MAJOR PROJECT ASSESSMENT: *Barangaroo*

Director-General's
Environmental Assessment Report
Section 75I of the
Environmental Planning and Assessment Act 1979

February, 2007

The Concept Plan (see **Figures 4, 5 & 6**) seeks approval for the following:

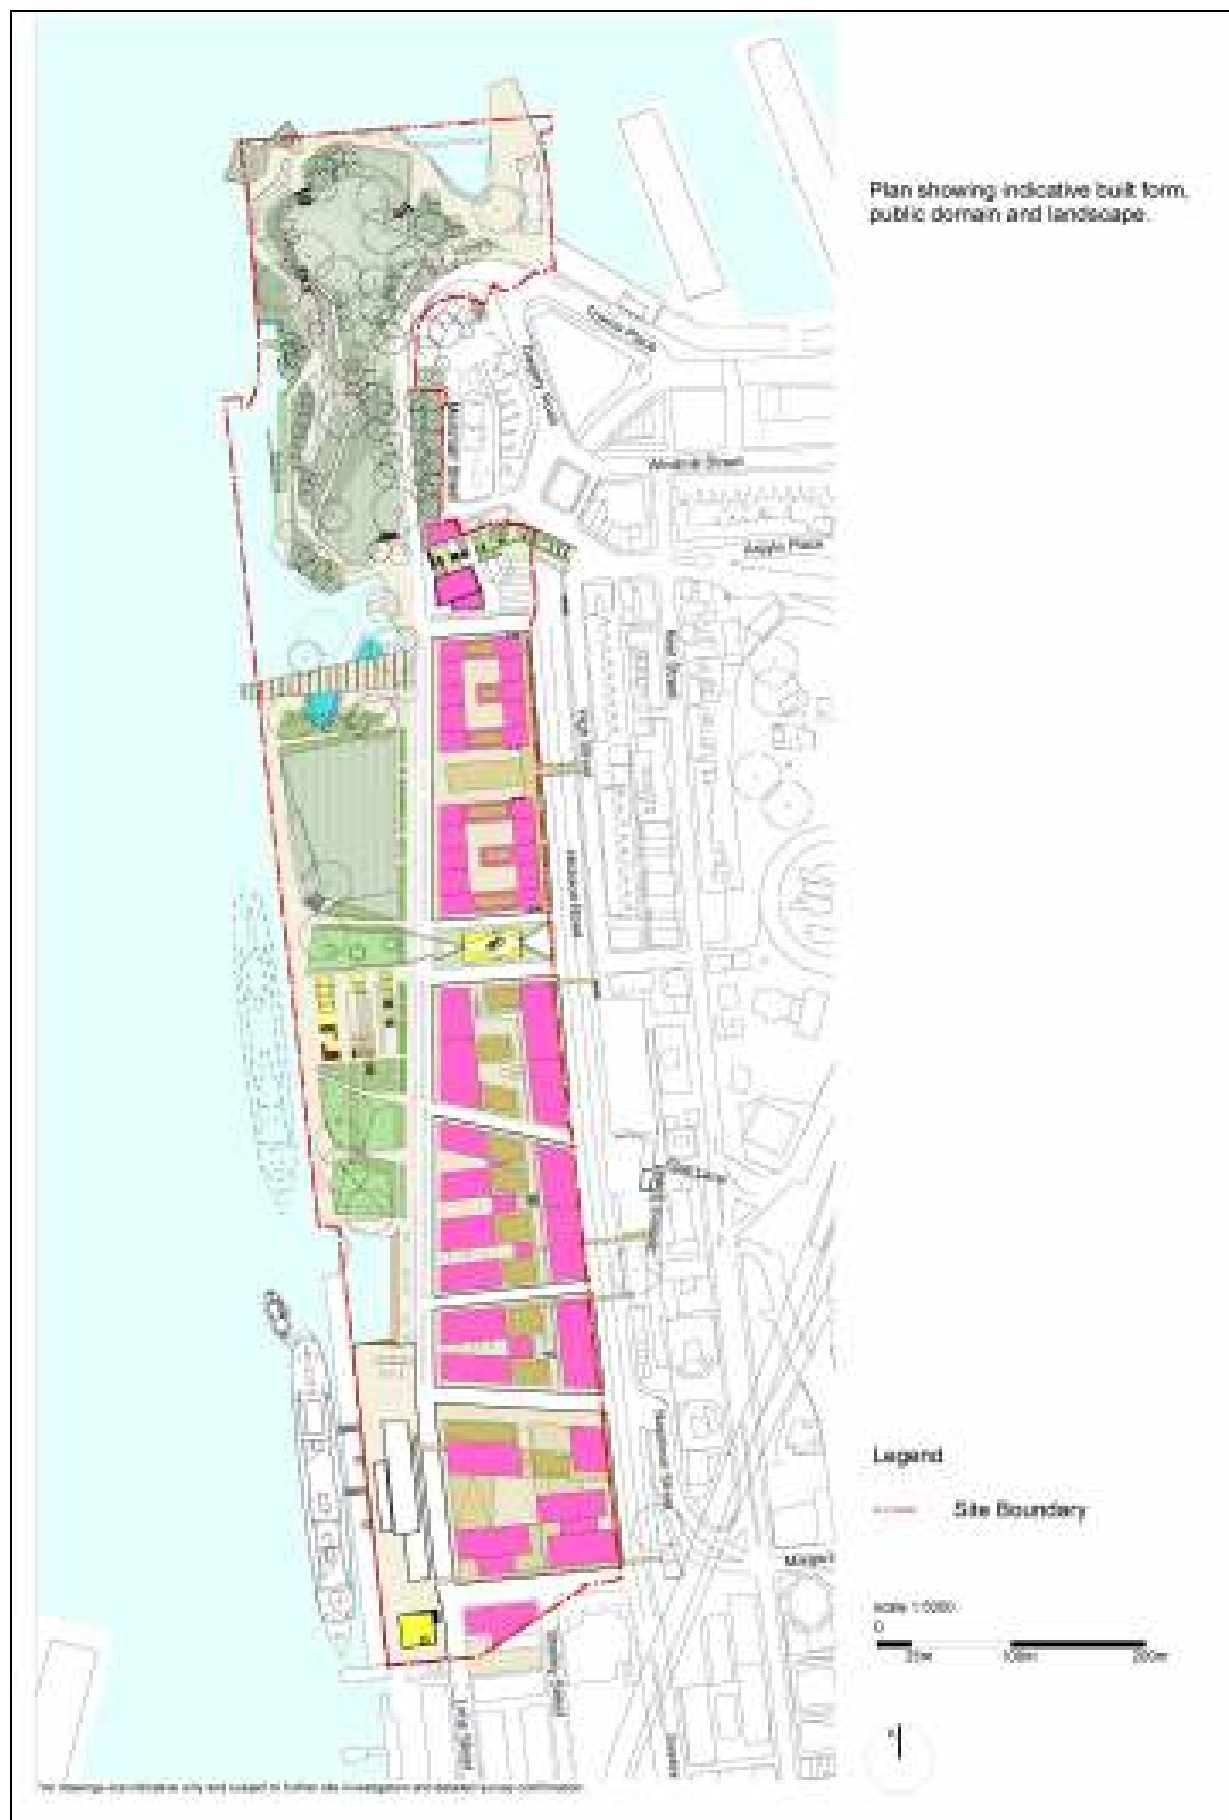
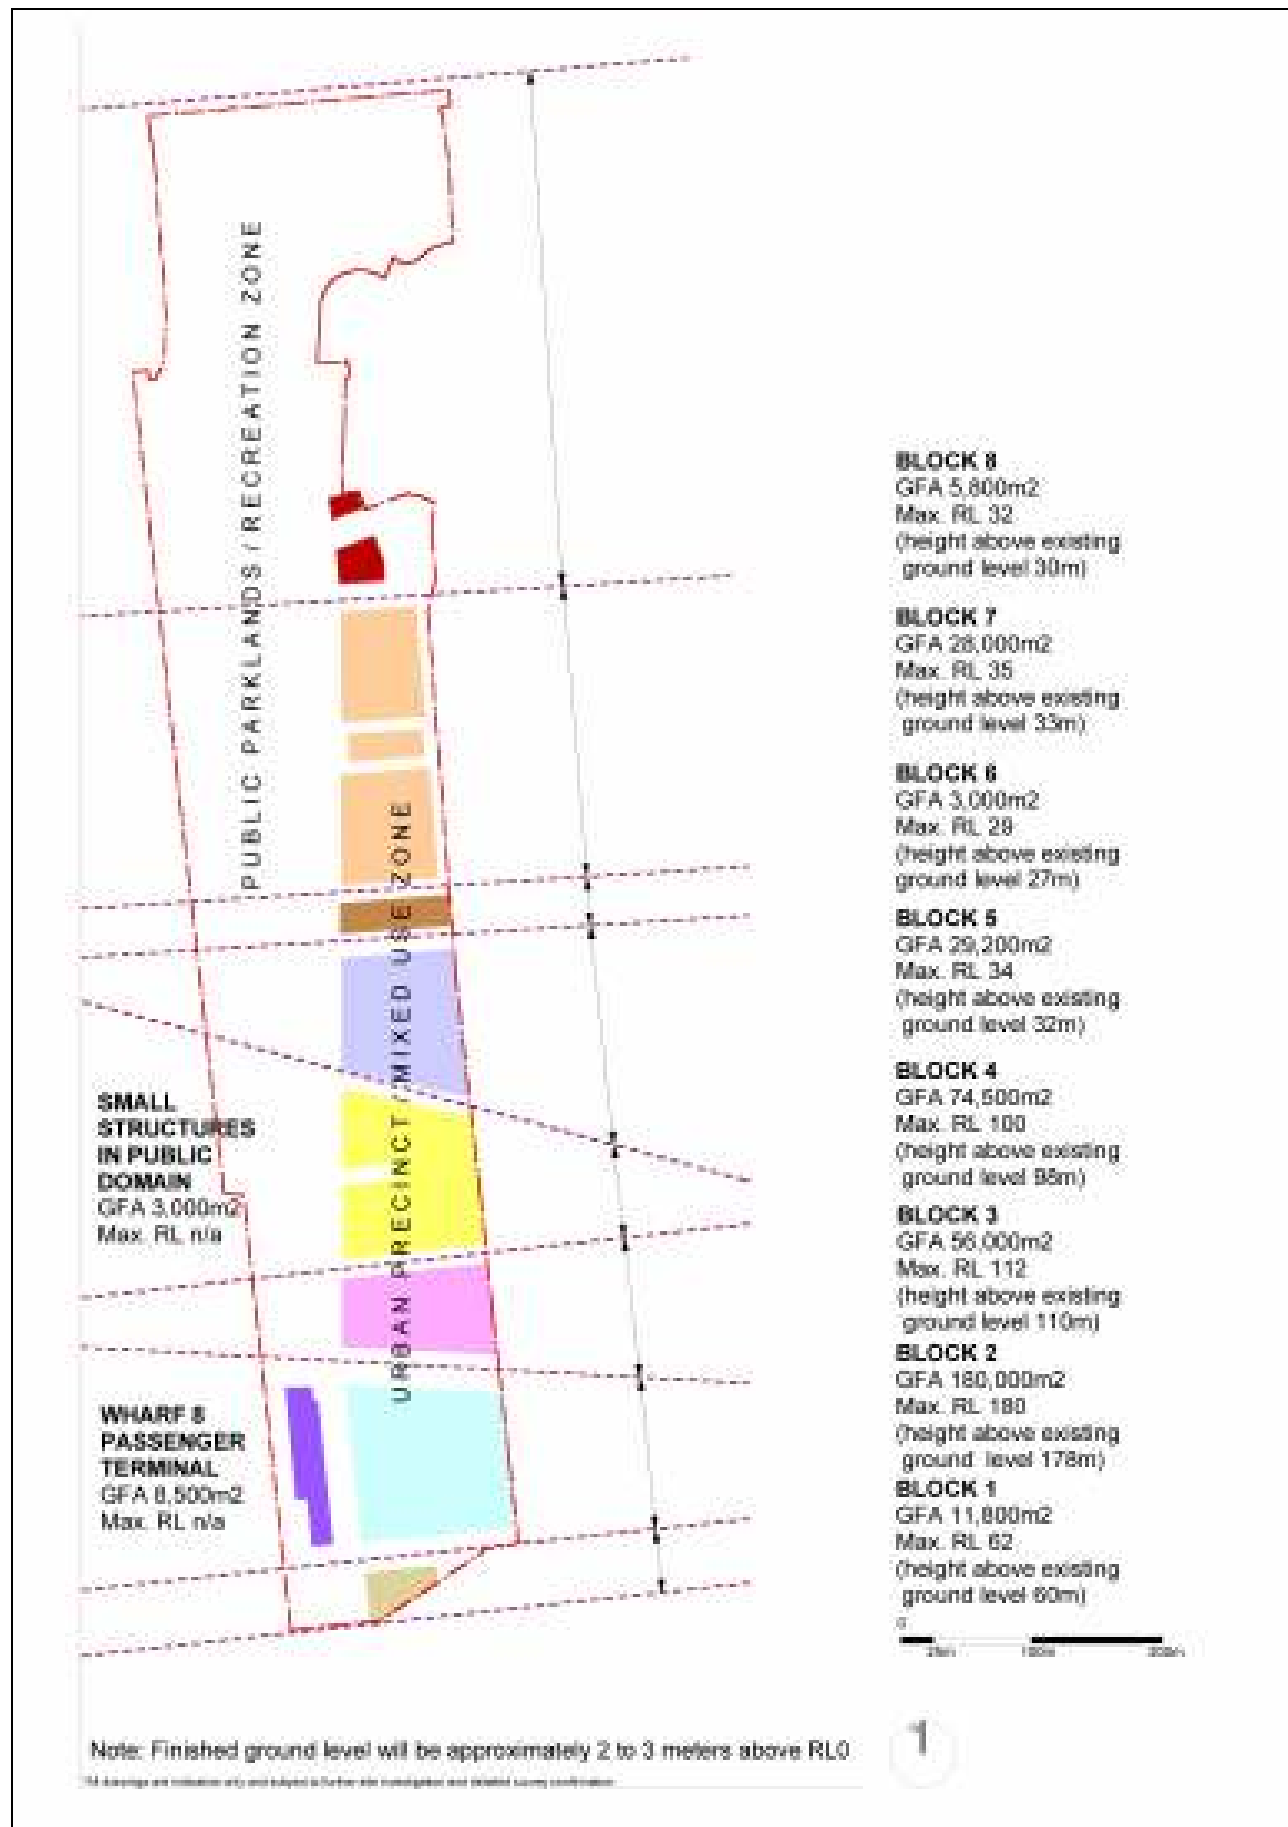
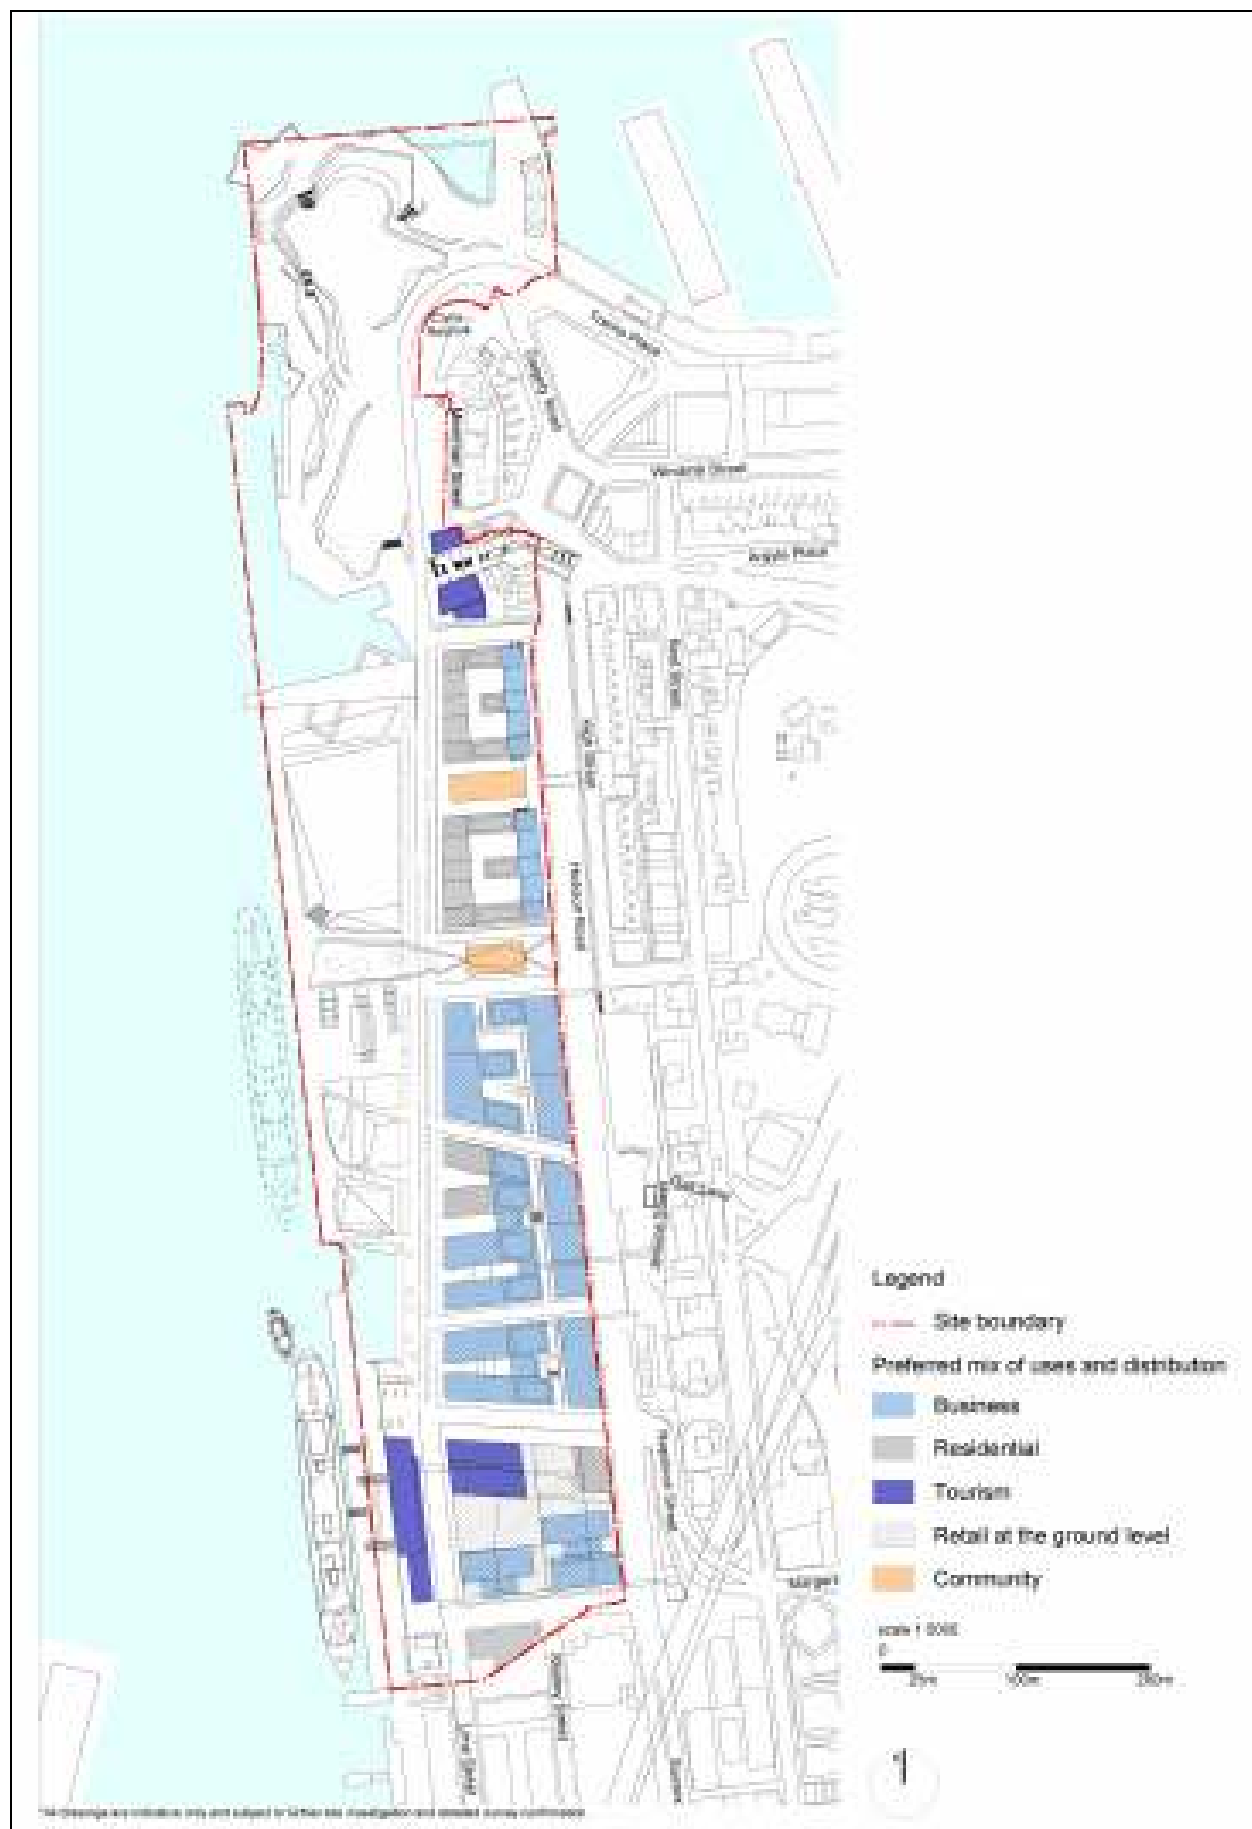
While a number of changes have been made to the concept plan in an attempt to reflect the Jury recommendations, particularly to the form of the northern headland, the Department considers the concept plan still does not satisfactorily address the jury's recommendations. The Department concludes that the following further modifications are necessary:

The Department recommends that the Concept Plan be modified to ensure that jury recommendations in relation to the Northern Headland, Northern Cove, and Southern Cove are implemented.

As discussed in **Section 6.2.1** the Department has responded to the jury's recommendations by including a number of modifications to the public domain. The modifications will result in the enlargement of the southern cove in to Building Blocks 3 and 4 (see **Figure 5**). This in turn may displace the GFA within these blocks. In response to this issue the Department recommends that the concept plan be further modified to allow for the redistribution of the displaced GFA across Building Blocks 2, 3 and 4.

The Department's view is that the built form controls for each development block identified in *Section 13.3 – Development Block Controls* (pages 120-137) of the EA, should not be approved, although the overall floor space, height and uses should. The indicative built forms, particularly to the north, do not provide appropriate street edges to Hickson Road or the west. Not approving building forms allows for evolution of design excellence and the creation of more appropriate street edges and urban forms to Hickson Road and 'Globe Street'.

The Department recommends that modifications be incorporated that ensures future project applications comply with the following:

- Buildings are not to exceed the heights and GFA's identified in *Figure 12.1 – Development Blocks* (page 107) of the EA.
- Building designs are to address the principles outlined in *Section 13.0 – Built Form* (pages 112-116) of the EA and the following new design principle which requires buildings to provide a consistent street wall and form to Hickson Road and "Globe Street" and use a palette of consistent and natural materials that are complementary to the sandstone nature of the headland.
- Provide a comparison, and outline any variations from, the block controls outlined in *Section 13.0 – Built Form* (pages 120 - 137) of the EA.
- Be subject to design competitions and a policy of design excellence.
